APPEAL SUMMARY

Appeal ID: 14914	Project Address: 1177 SW Market St
Hearing Date: 4/12/17	Appellant Name: Michael Barrett
Case No.: B-009	Appellant Phone: 503-445-7895
Appeal Type: Building	Plans Examiner/Inspector: Kathy Aulwes
Project Type: commercial	Stories: 14 Occupancy: R-2 Construction Type: 1-A
Building/Business Name:	Fire Sprinklers: Yes - Fully Sprinklered
Appeal Involves: Erection of a new structure	LUR or Permit Application No.: 16-173209-CO
Plan Submitted Option: pdf [File 1] [File 2] [File 3] Proposed use: Multifamily Apartments

APPEAL INFORMATION SHEET

EX 2 - RADON CONTRL METHODS
1177 SW MARKET ST. - 4.5.17

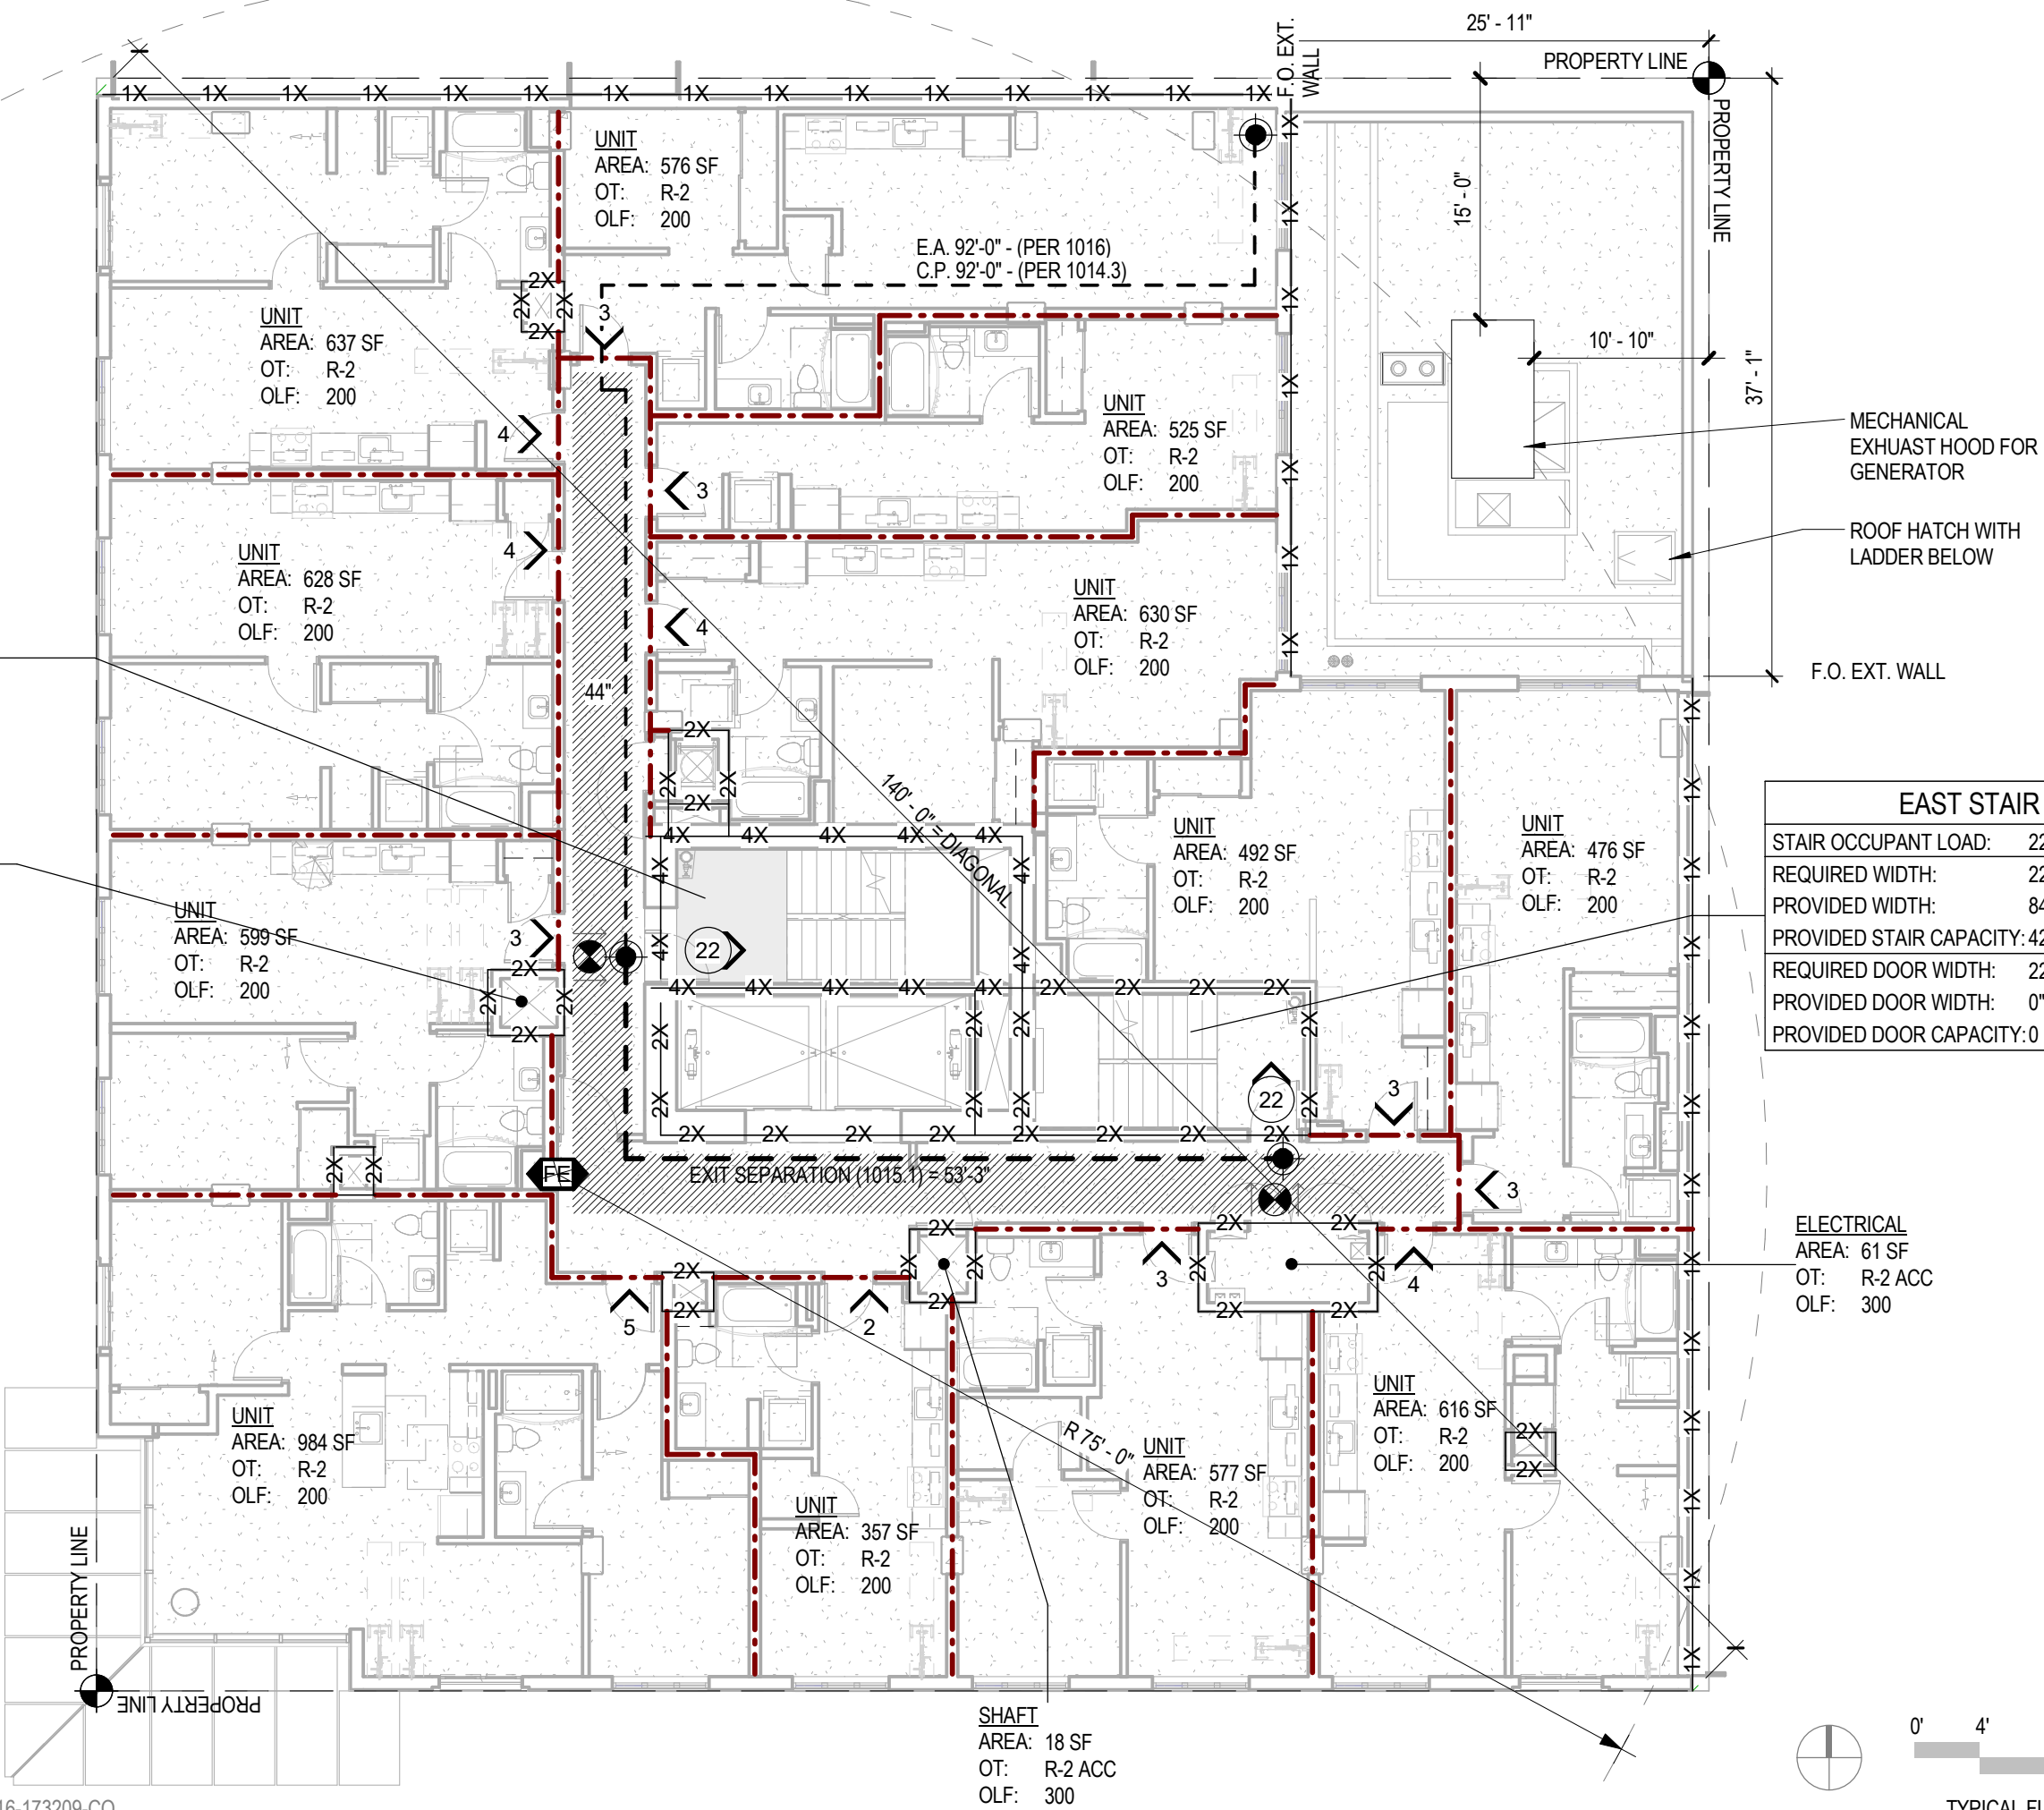
Proposed Design

See Exhibit 02 - Radon Control Methods for more information:

The proposed building is a quarterblock 14 story highrise, with parking, tenant amenity spaces and building support spaces on the ground floor with a mix of S, B and R-2 accessory occupancies. No dwelling units are located on the ground floor, with all R-2 accessory occupancy designated for circulation space.

All spaces on the ground level are mechanically ventilated and exhausted per IMC code requirements, adopting a similar approach to appeals 13547 & 10325.

Reason for alternative An active mechanical ventilation system on the ground floor exhausts potential radon gases prior to reaching residential spaces on the upper floors of the tower, particularly given the limited R-2 accessory use and lack of grade level living units. We believe that this approach, especially as previously adopted by other similar projects, meets the intent of Radon control methods.

2. Omission of radon control measures in mixed use building: Granted as proposed and provided continuous mechanical ventilation is installed in all first floor spaces.
